**DEC 18 2025****PUBLIC SERVICE  
COMMISSION**

Exie Solar LLC,

Case No. 2025-00151

**Figure C-22.**  
Non-participating home near gen-tie line and panel area

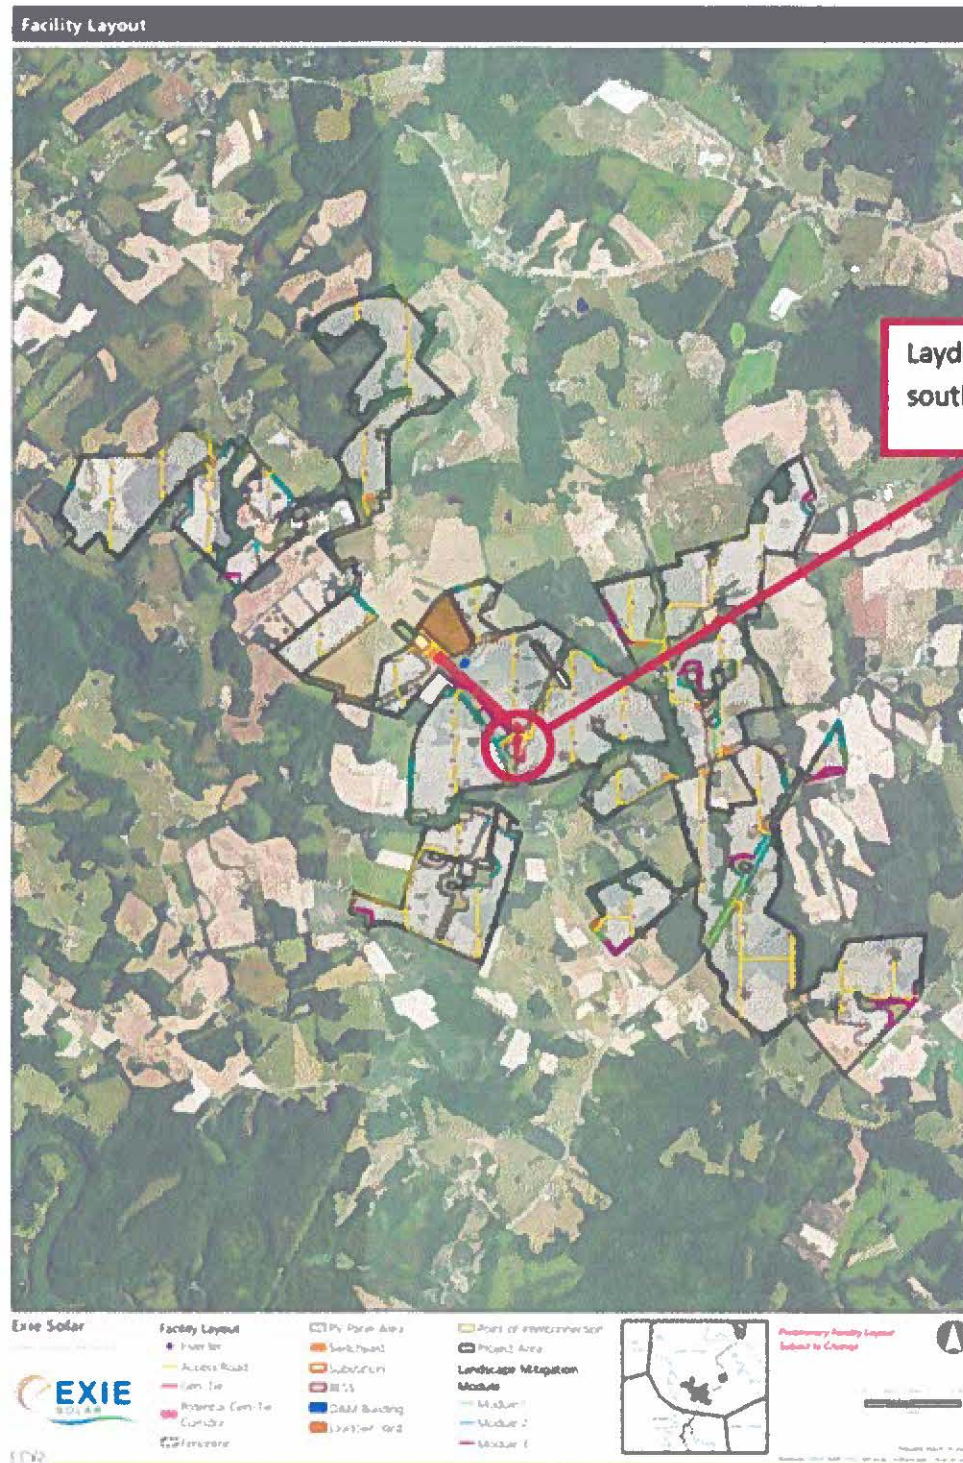
When Exie Solar first filed their Notice of Intent, they used 2969 Liletown Road as the street address for their Project. That address is actually the address of a non-participating landowner in our neighborhood. (see photo below).

Exie plans to construct access road #7 right next to this property even though there's plenty of road frontage available further away.

A laydown yard was also shown next to this property on an early Facility Layout map. I'm concerned that a laydown yard will make its way back to this location in the Final Site Plan.

Exie Solar, Application pdf, Exhibit E, Appendix B, pg. 47. Facility Layout map.

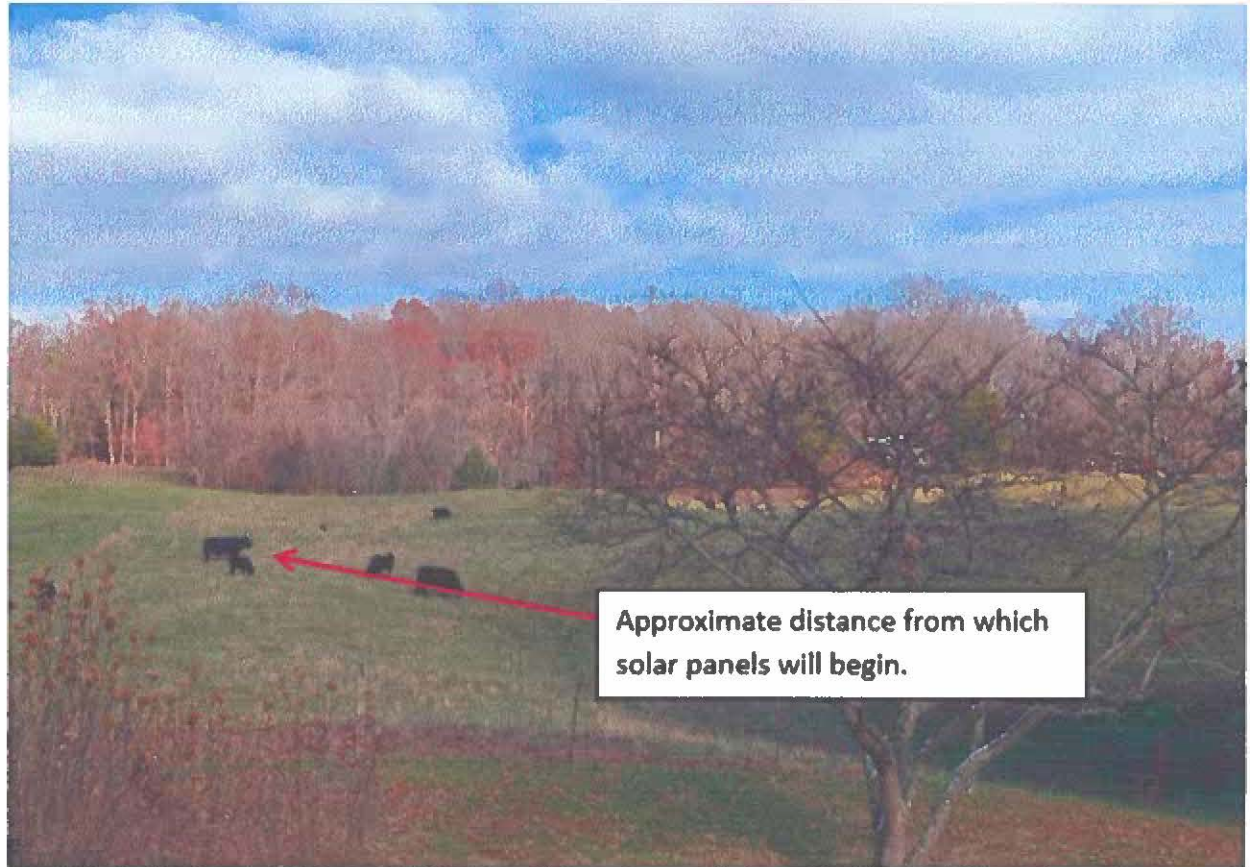
Exie says the transmission lines will be 185 feet from our house with a 100-foot right-of-way. A sketch provided to the First Data Request, item #53 shows a 150-foot right-of-way, this would place the right-of-way for the transmission lines 30 feet from our property line.

Parcels of land behind our house, where the existing EKPC lines are located, extend back from our property by about 1,700 feet and have no residential structures.

Selecting a Point of Interconnection farther back on those parcels would increase the distance of the Exie's transmission line route away from our neighborhood and potentially reduce their length.

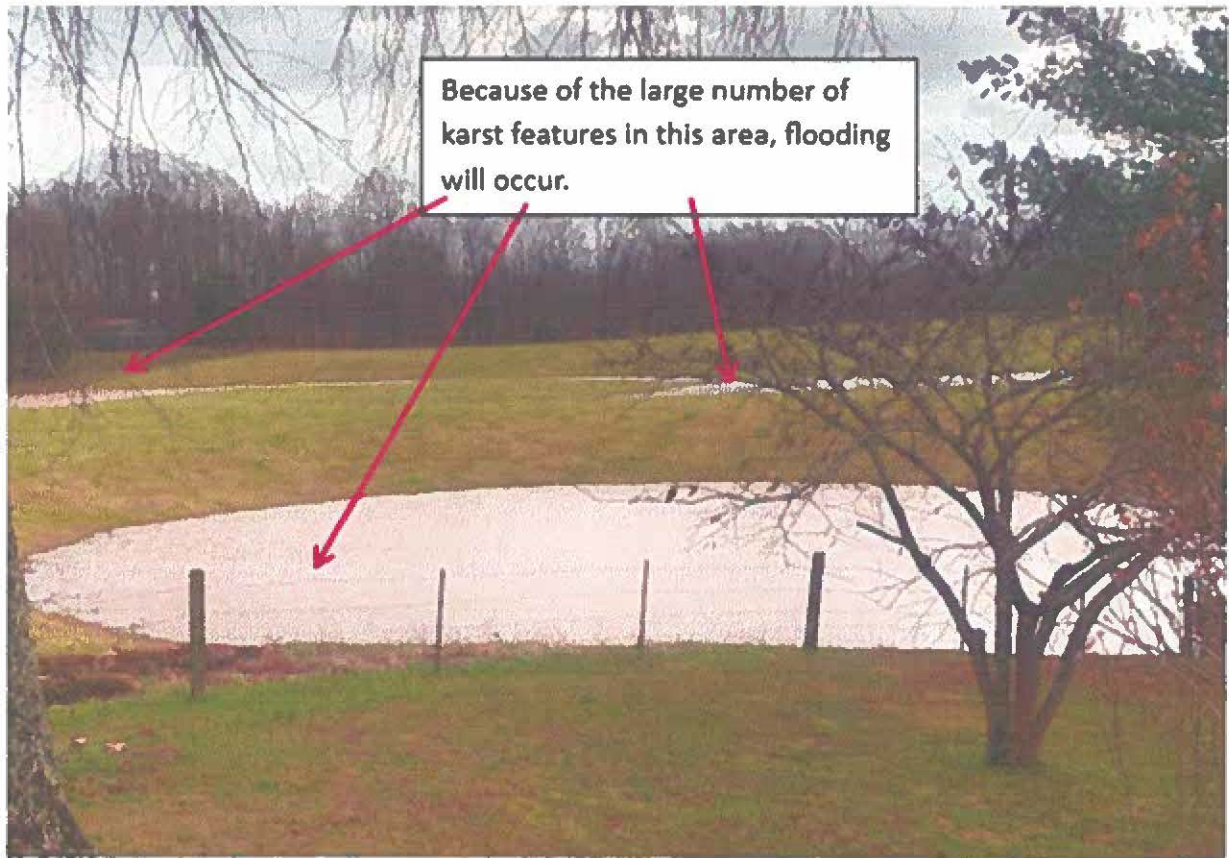
The parcels of land behind our property contain a wooded area of approximately 18 acres that is slated for clearing. It also contains "BTA 10." Which is one of seven habitats that are in areas to be clear.

Because of the topography behind our home the Module 3 vegetation screening planned for this area will do little to minimize the visual impact of this project to the viewshed from our property.

Photo 17: View of representative perennial stream, Greasy Creek, facing southwest.

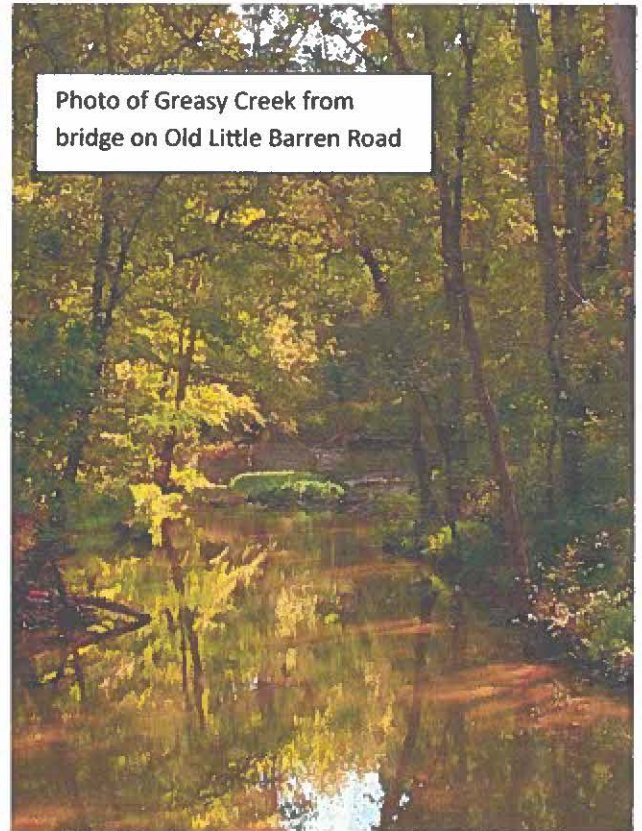
According to the Second Data Request, Item #19,b. Exie Solar intends to apply a 25-foot setback to mitigate impacts to karst features. The Terracon Report that was completed in 2024 but only submitted two days ago notes that water runoff from the project flows into Greasy Creek. Terracon Report also recommends a 50 foot setback from karst features.

Greasy Creek can look different from different perspectives.

Photo of Greasy Creek from  
bridge on Old Little Barren Road

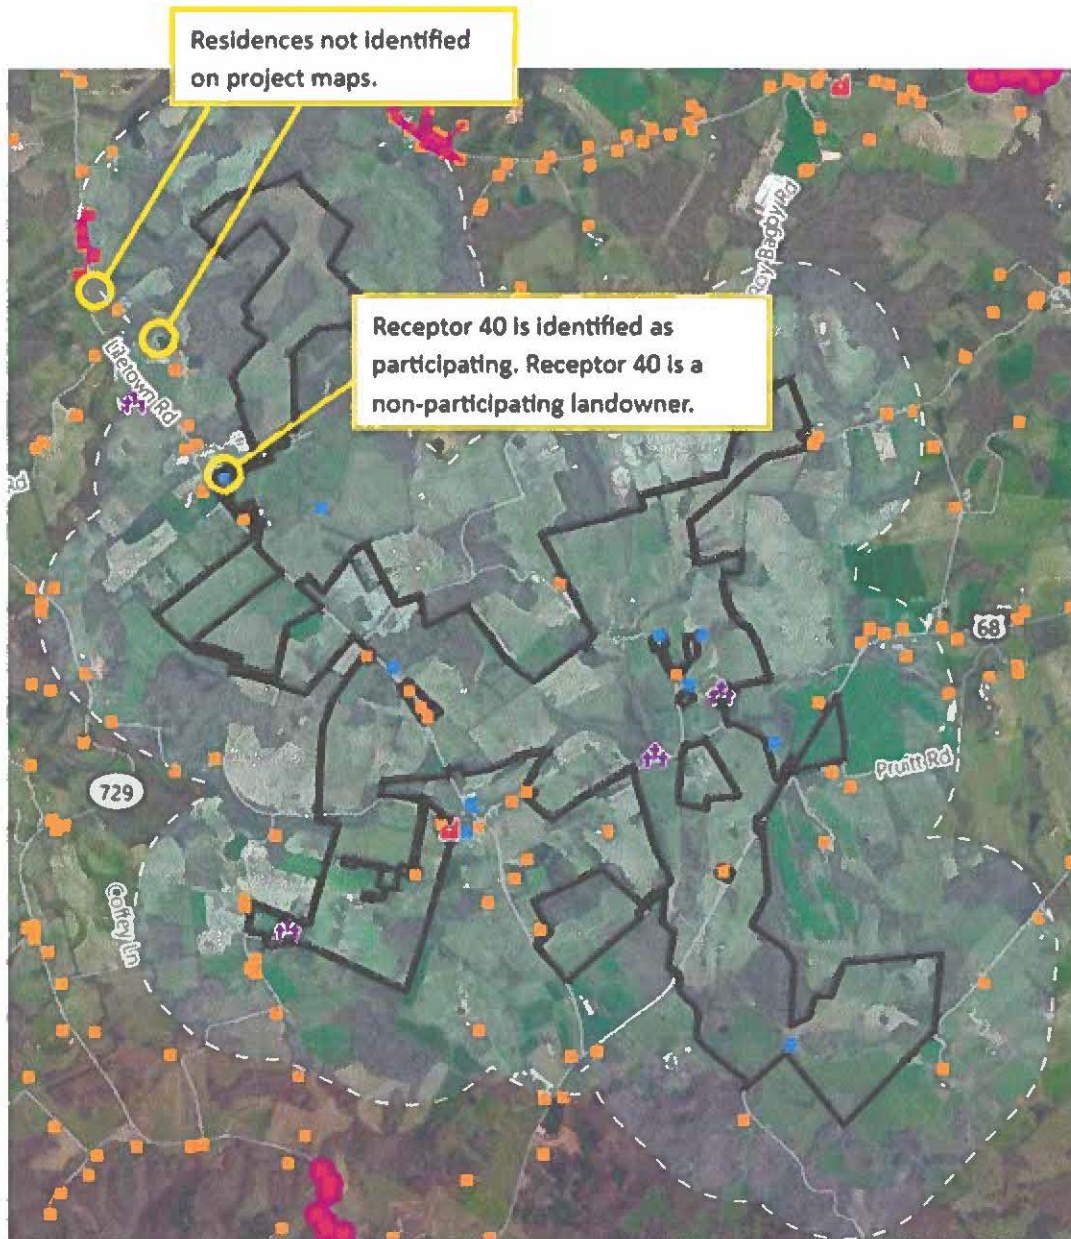
Greasy Creek can be extremely  
active. Photo taken from along  
Old Little Barren Road.
